CITY OF ALBUQUERQUE

Planning Department
Alan Varela, Director

Re: Broadway Apartments
314 Broadway SE
Traffic Circulation Layout
Engineer's/Architect's Stamp -no stamp- (K14D232)

FIGURE 7.4.117 ADA Accessible Parking Stall and Access Aisle Dimensions

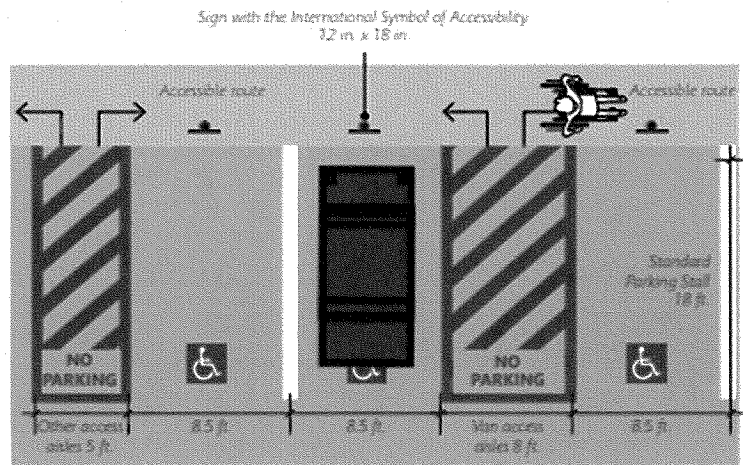
13. Provide the dimensions for the parking stalls and the ADA Van Access.
14. Provide a dimension for the overall site width.
15. The pavement markings for the ADA access aisle should be blue diagonal stripes. See below.
